Third Party Protection Audit at the following Substaions of Resonia:

CENTRAL BOARD OF IRRIGATION & POWER

OBSERVATIONS DURING AUDIT OF 220 kV/ 132 kV NANGALBIBRA SUBSTATION OF RESONIA GROUP

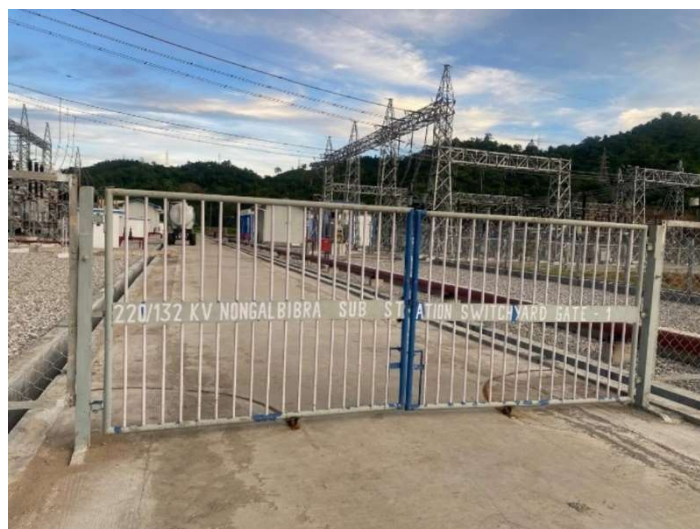
Proper Earthing of Switchyard Gates has to be provided. In this regard IEEE 80 recommends as under:

“The ground grid should extend to cover the swing of all substation gates. Gate posts should be securely bonded utilizing a flexible connection”.

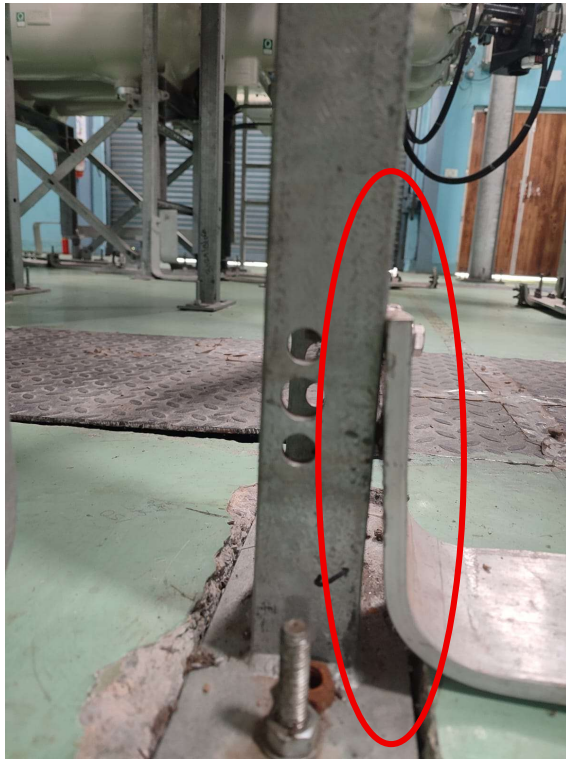
Earthing of GIS structure of NBTL bays was inspected, it was observed that earth strip was not making proper contact with the support structure near Nangalbibra Ckt-1 bay. Since, earthing of equipment is of paramount importance for safety, it is recommended to get it rectified at the earliest opportunity.

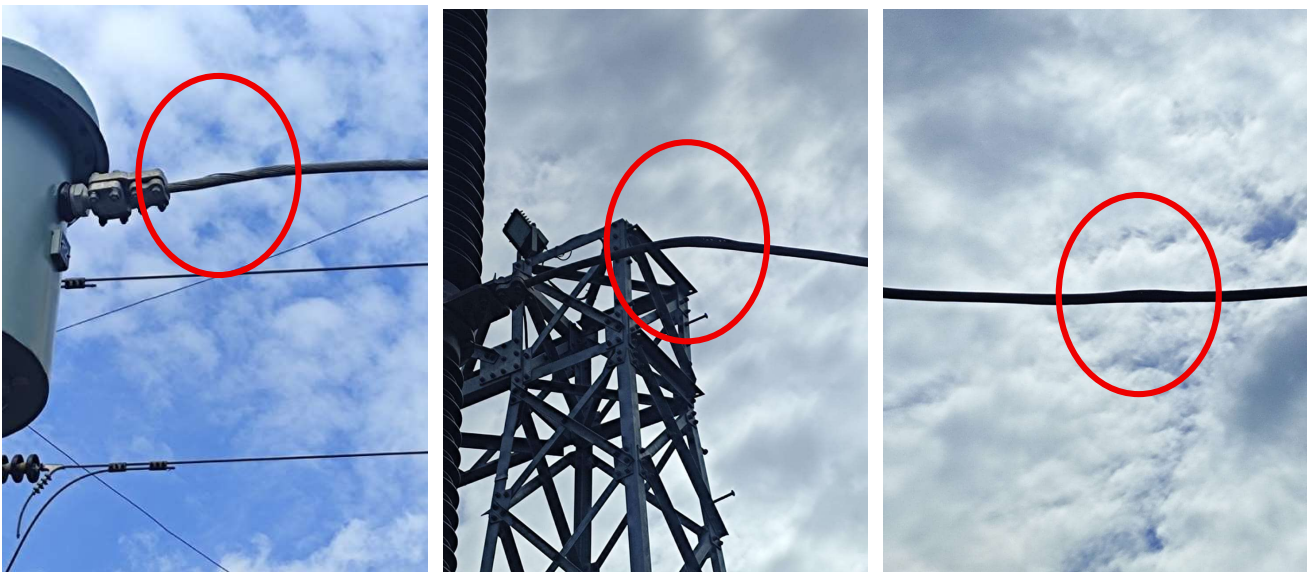
Third Harmonic Resistive Current (THRC) of LAs was measured after charging of the system on 07.09.2024. The leakage current values reviewed were found to be within prescribed limit. It is suggested that the measurement of THRC be undertaken pre-monsoon and post-monsoon basis to ensure healthiness of the LAs.
